STATE OF NORTH CAROLINA
DEPARTMENT OF TRANSPORTATION

September 12, 2011

Subject: Permit Modification Request for the Section 404 Individual Permit, Section 401 Individual Water Quality Certification and CAMA Consistency Certification for the proposed improvements US 17 (Western Parkway) from SR 1403 (Country Club Road) to Western Boulevard in Onslow County. Federal Aid. No. STP-NHF-17(63), TIP No. U-4007B, Debit \$570 from WBS 35008.1.1

Revised 7/5/2011
Permit Drawing
Sheet 7 of 8

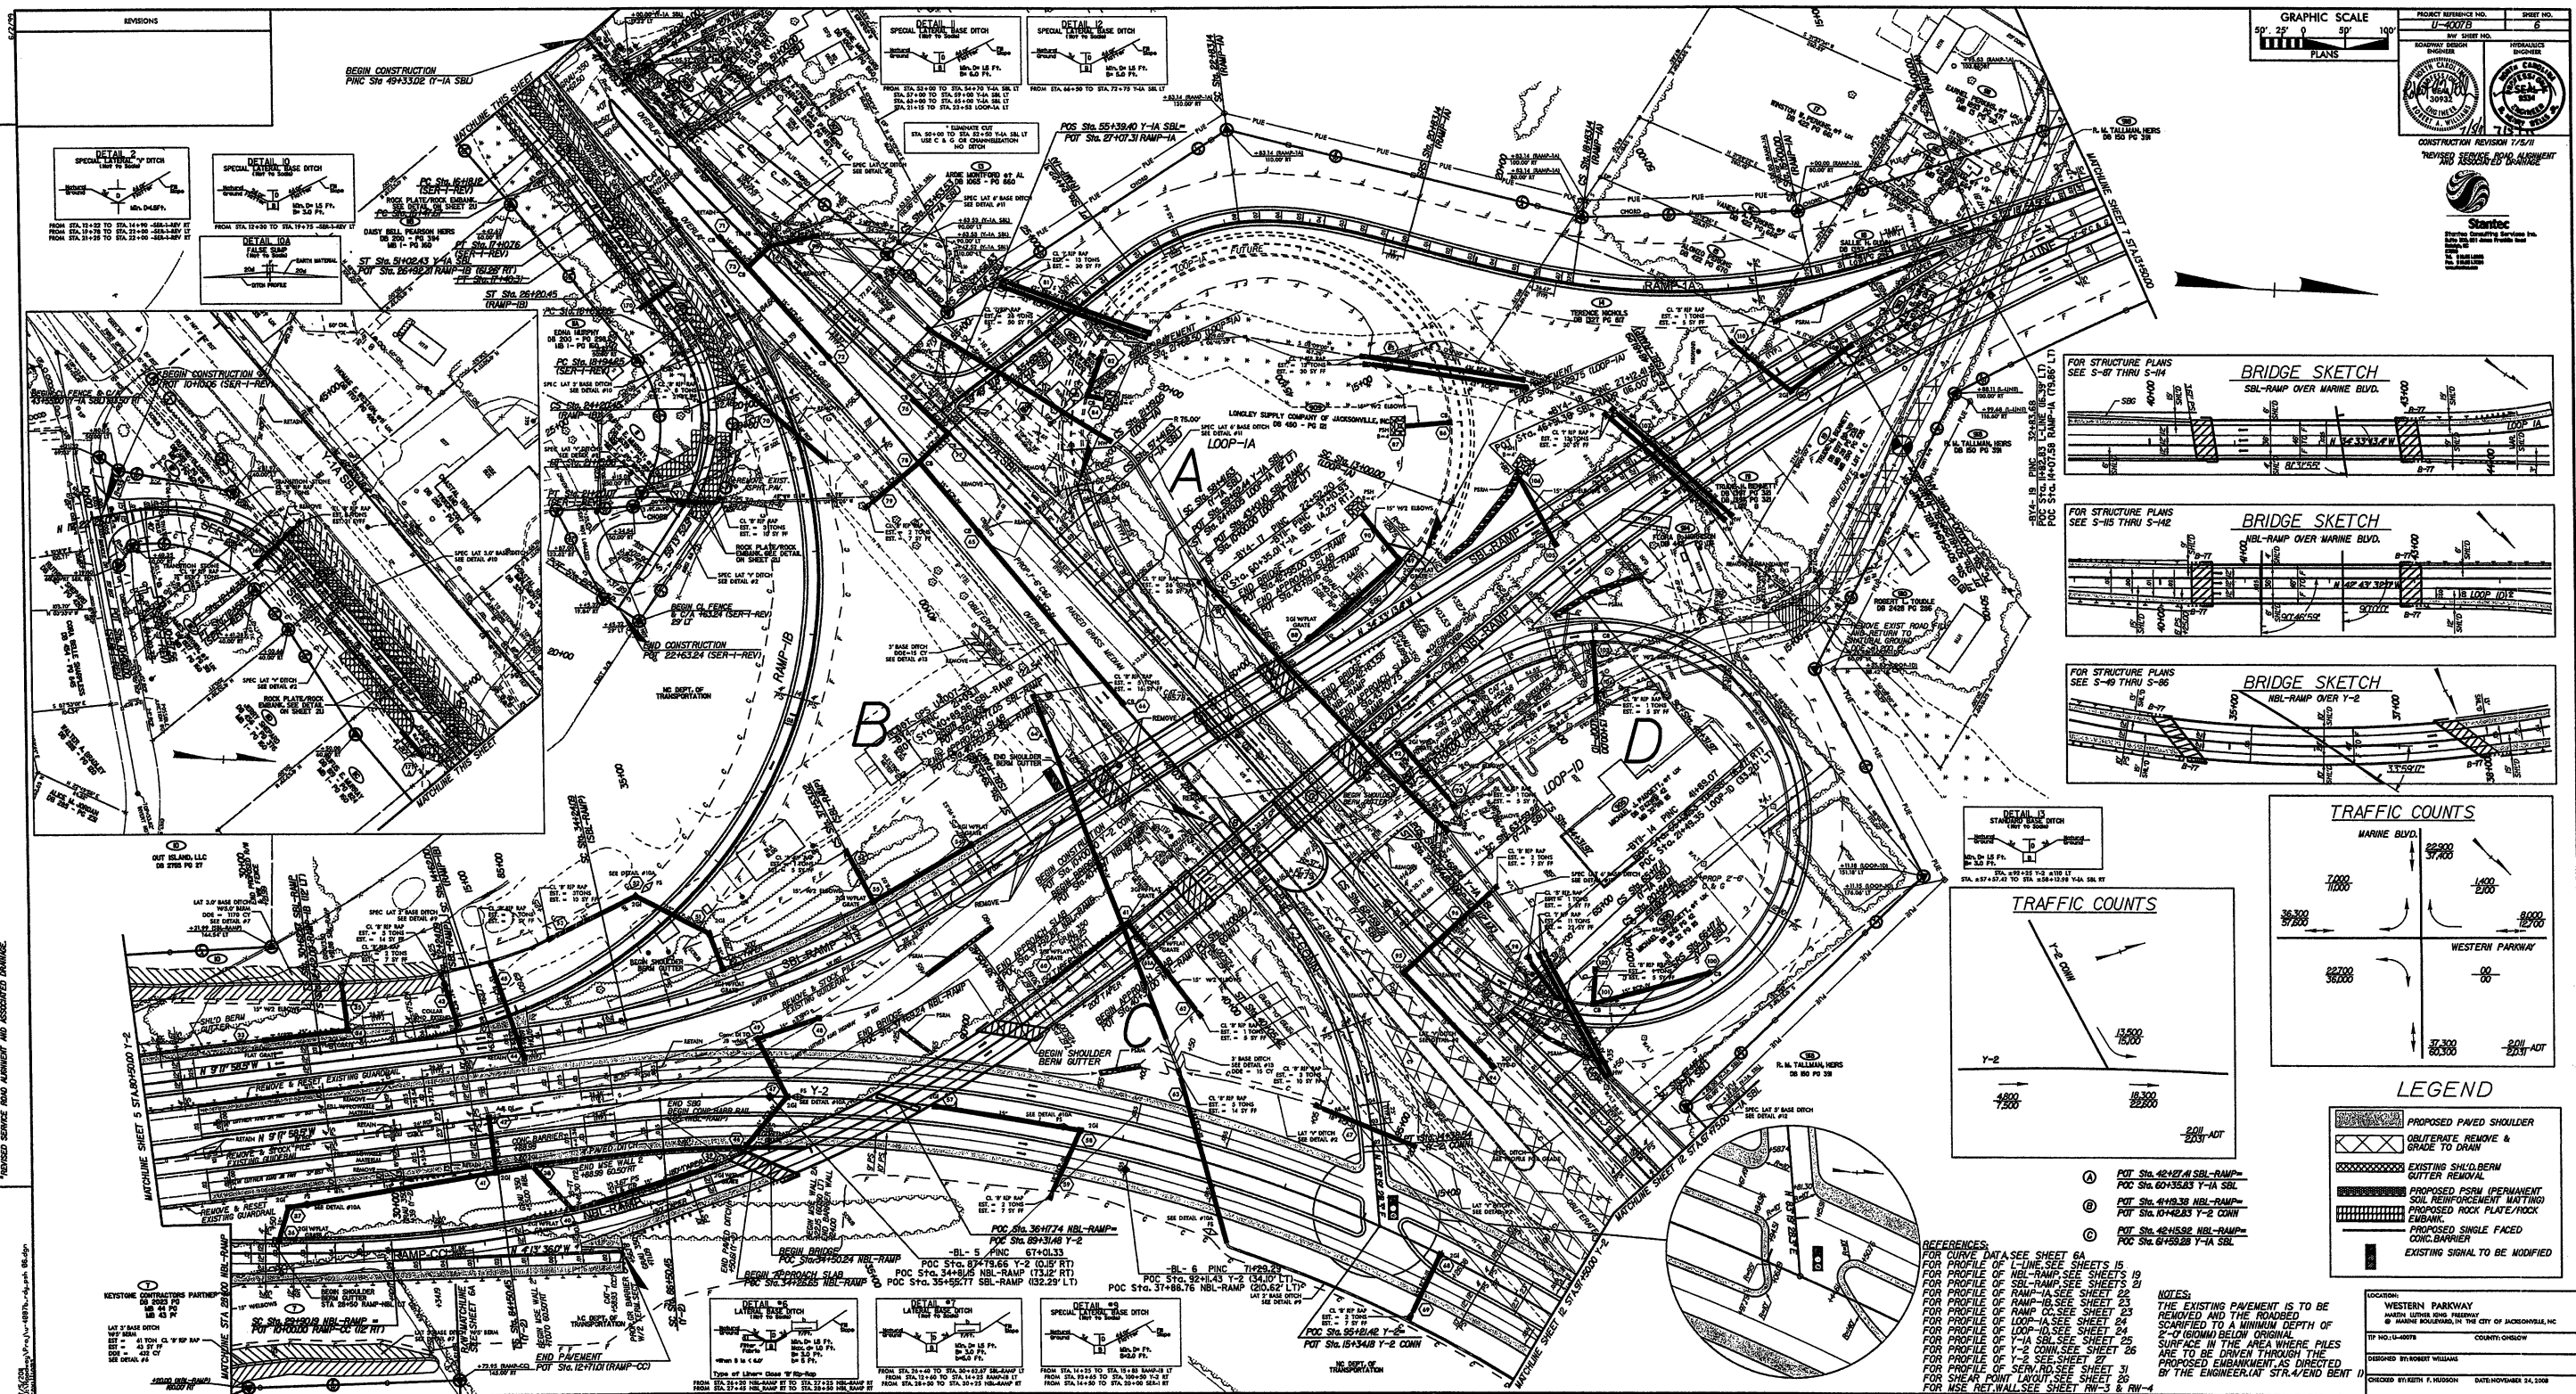
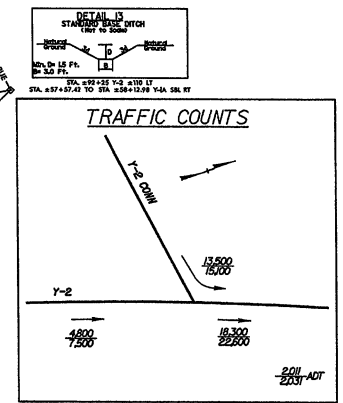
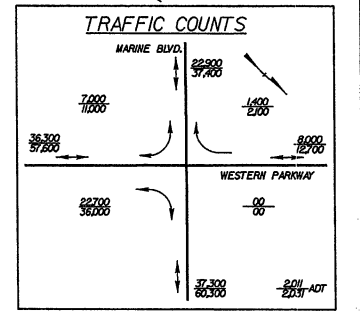
CONSTRUCTION REVISION 1/5/11

REVISED SERVICE ROAD ALIGNMENT AND ASSOCIATED DRAINAGE
